80 Charlotte Street

— 05 Conclusion

This minor material amendment application seeks to complete the demolition of the original 1960's post office building due to the conditions of the existing structure. The additional demolition sought results in amendments to the facades which have been discussed at the pre-application stage with Camden officers.

Proposed Charlotte Street elevation

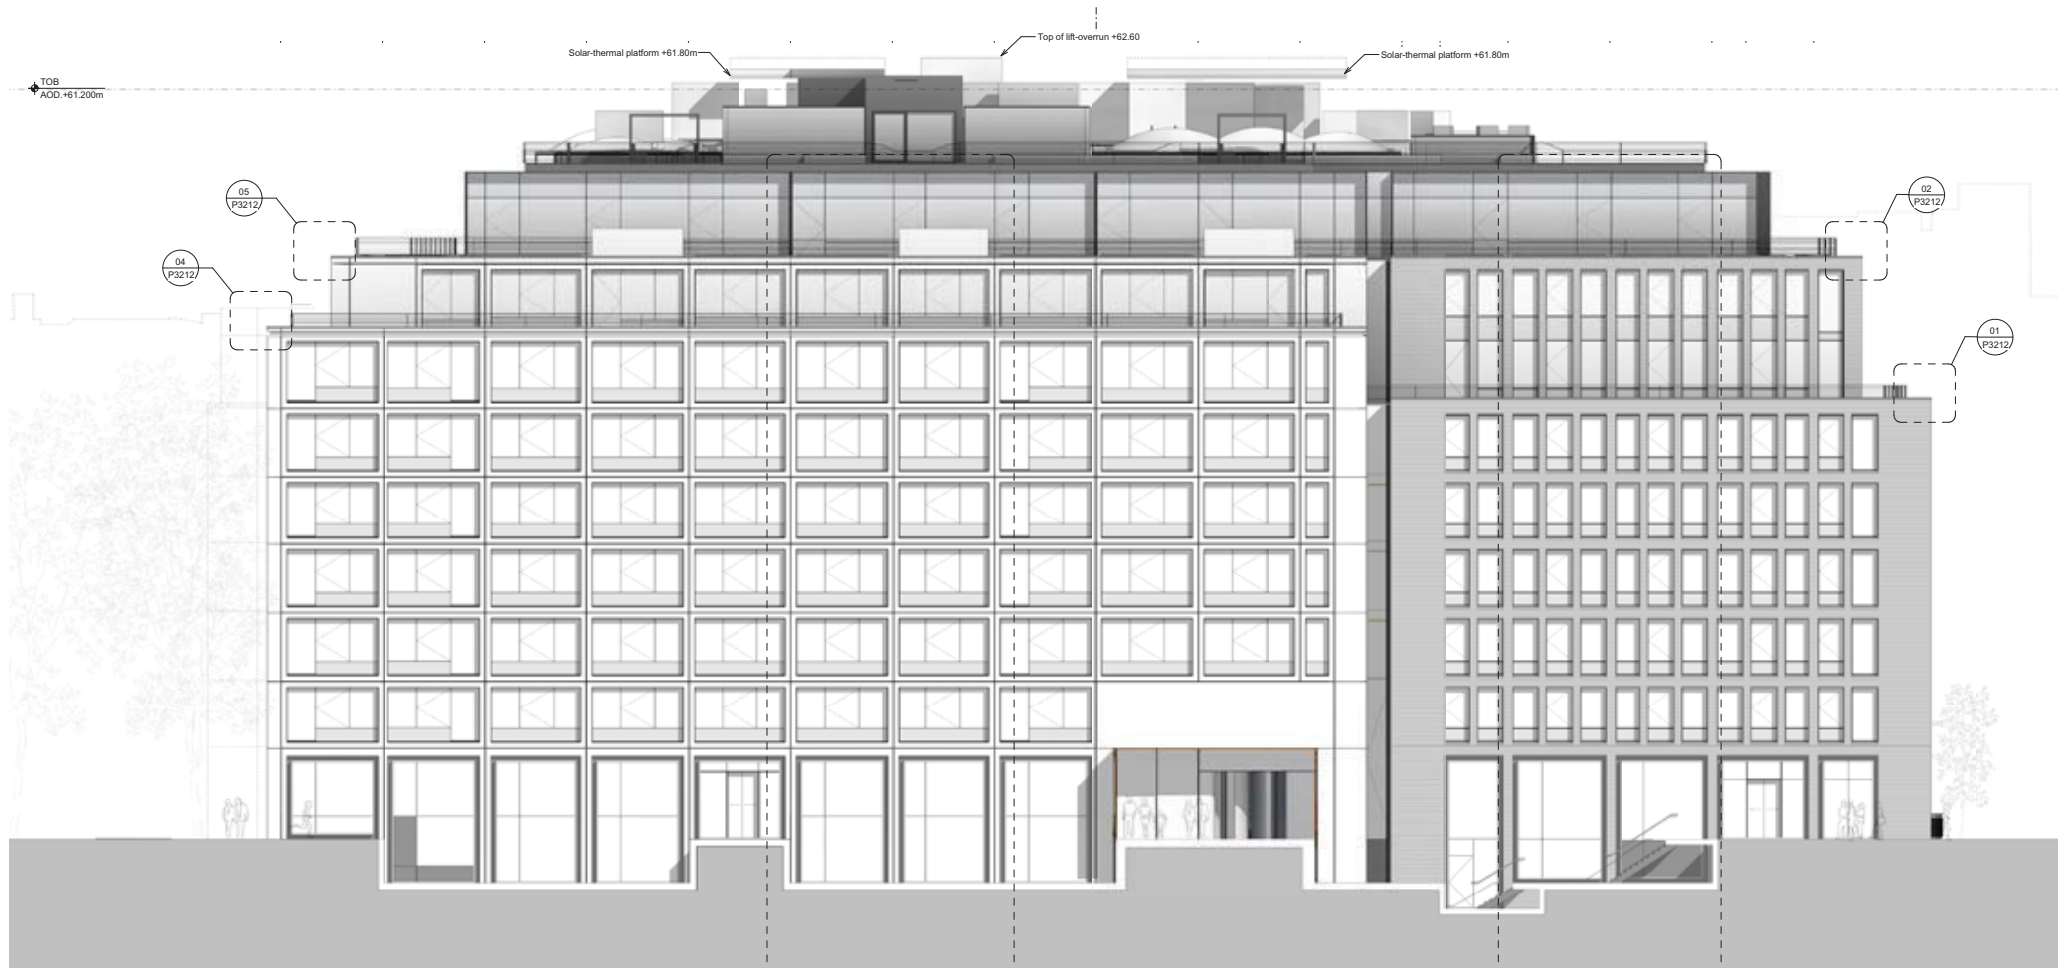
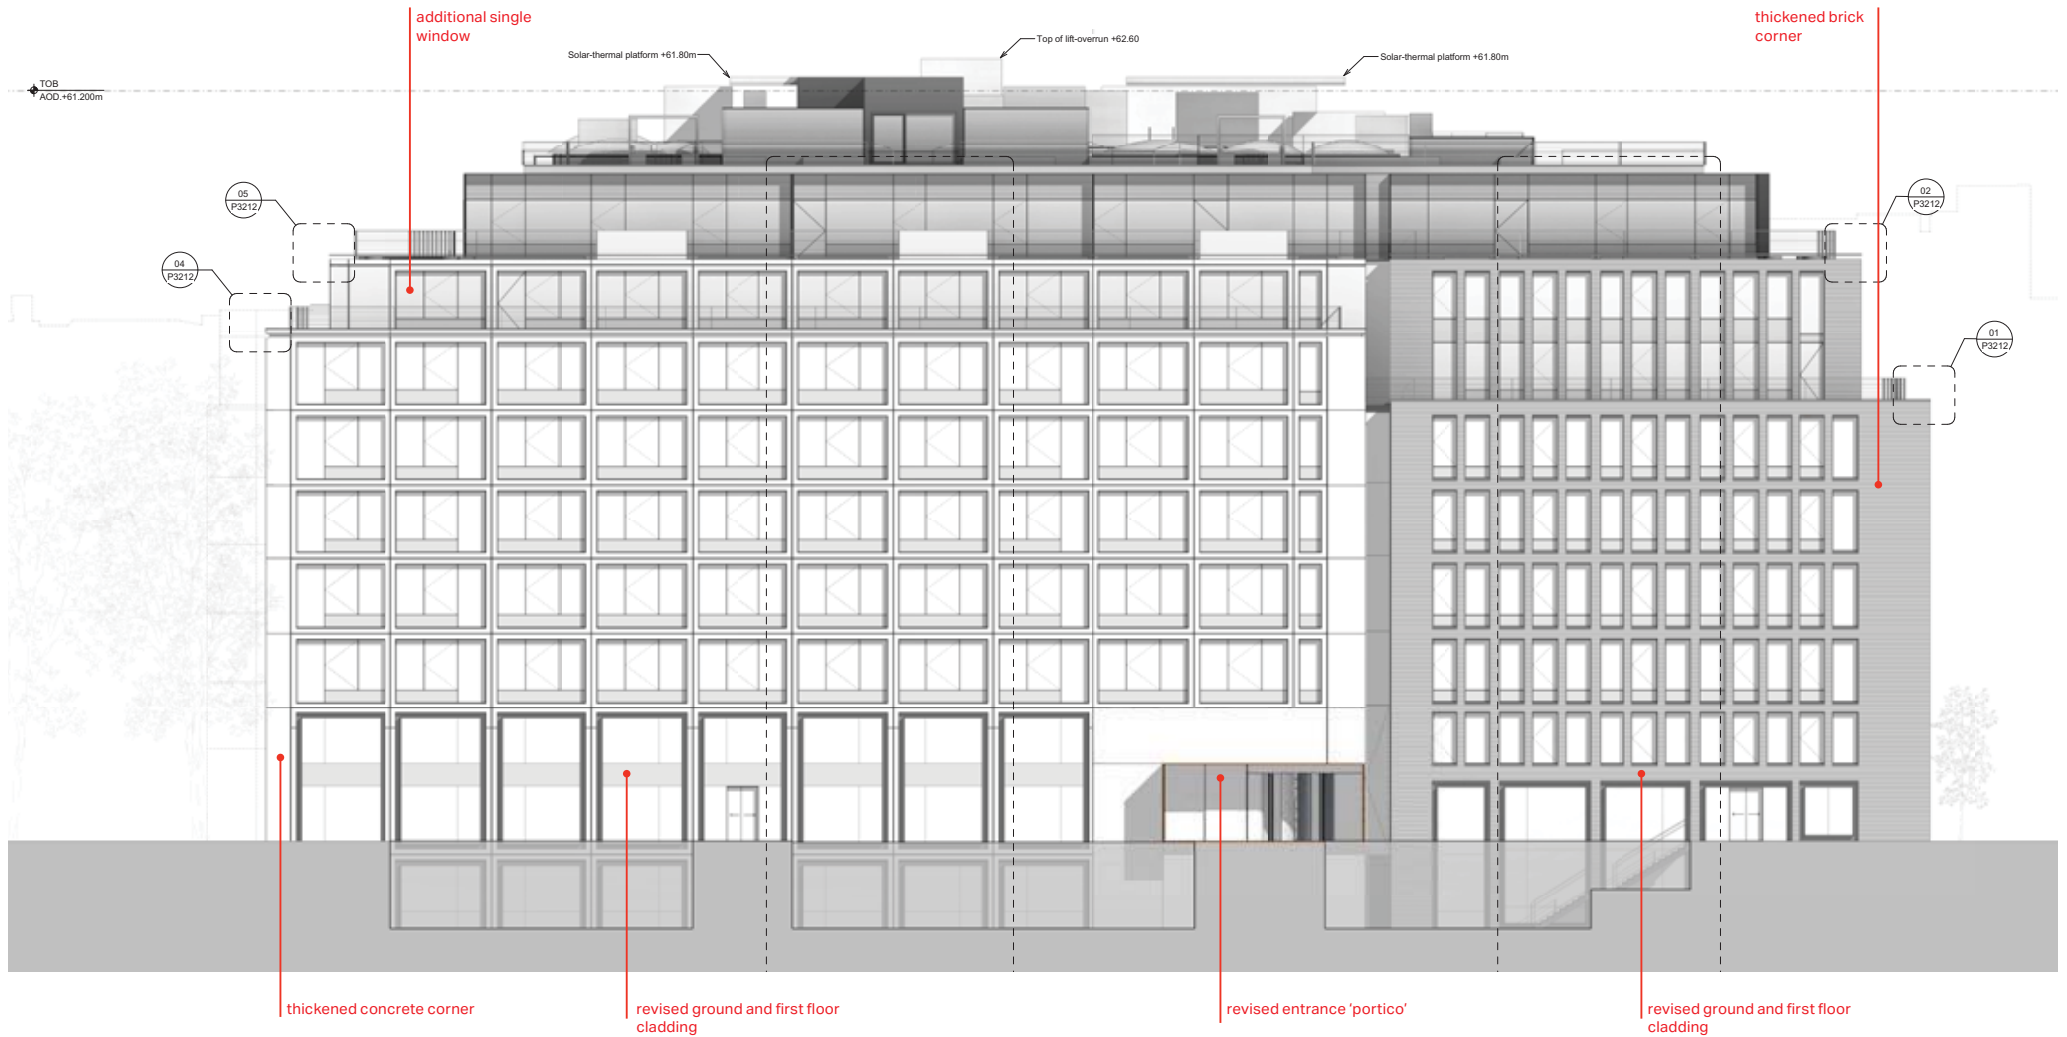
Revised Charlotte Street elevation following the new metric grid and reorganised lower ground, ground and first to fifth floor.

- The new ground floor elevation along Charlotte Street encompasses the first floor as either a double bay or narrowed first floor expression to maintain the consented 'tall' ground
- The corners and divisions between the 'individual buildings' are more solid to further define the separation

Proposed Howland Street elevation

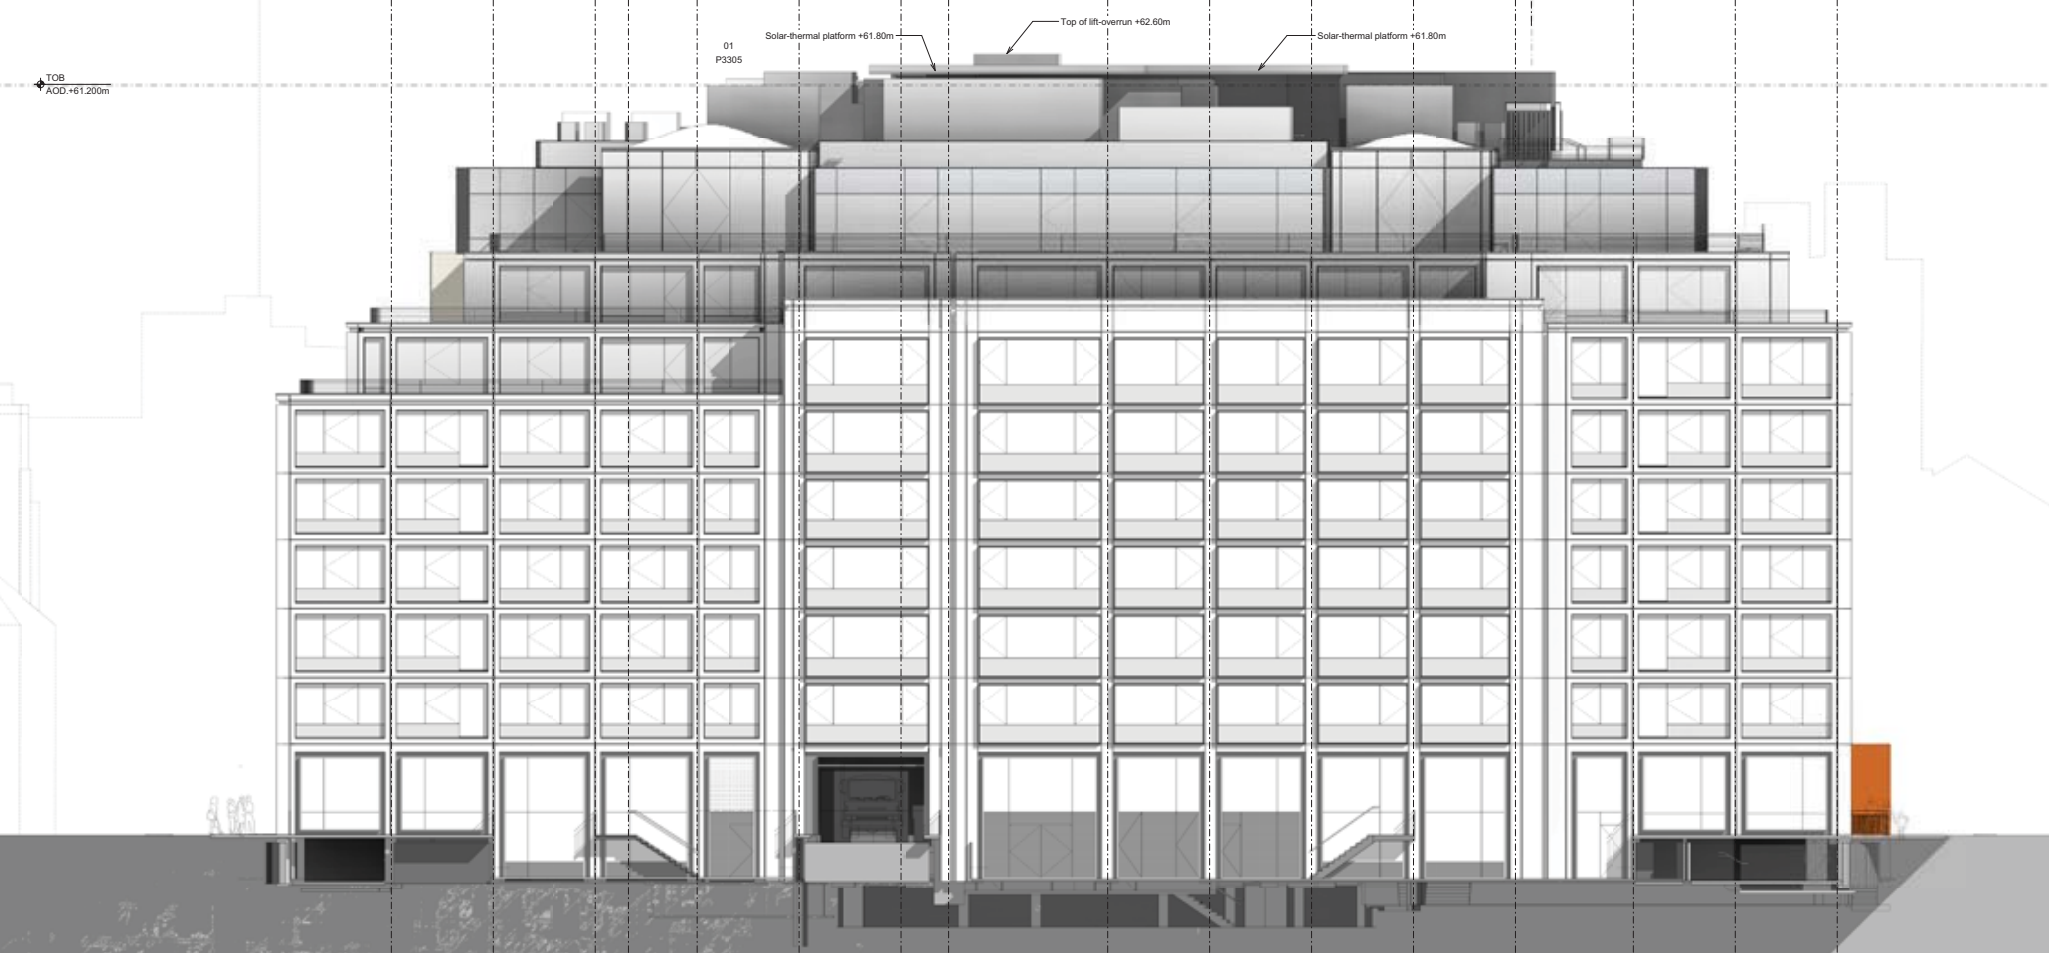
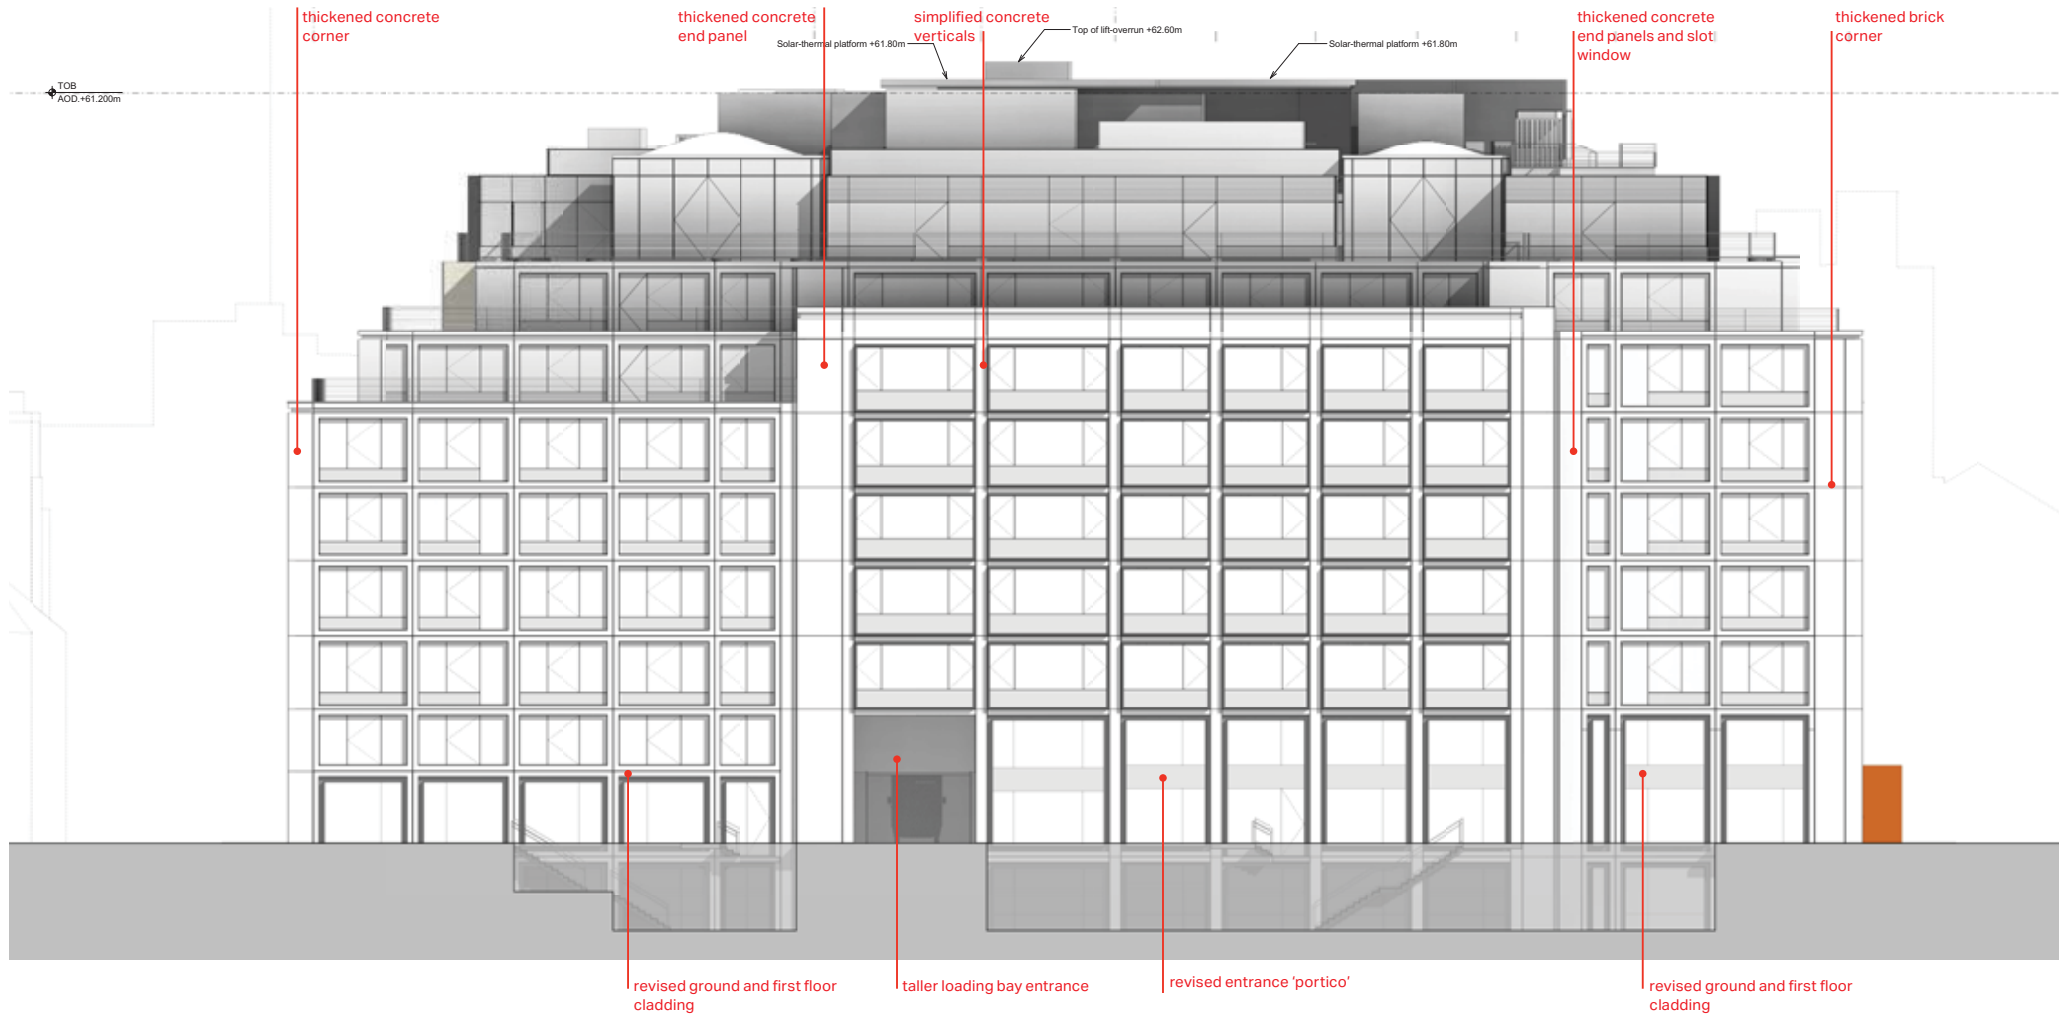
Revised Howland Street elevation following the new metric grid and reorganised lower ground, ground and first to fifth floor.

- The new ground floor elevation along Charlotte Street encompasses the first floor as either a double bay or narrowed first floor expression to maintain the consented 'tall' ground
- The corners and divisions between the 'individual buildings' are more solid to further define the separation

- The central 'building' is further defined by simplifying the concrete verticals to form a more coherent individual 'building'
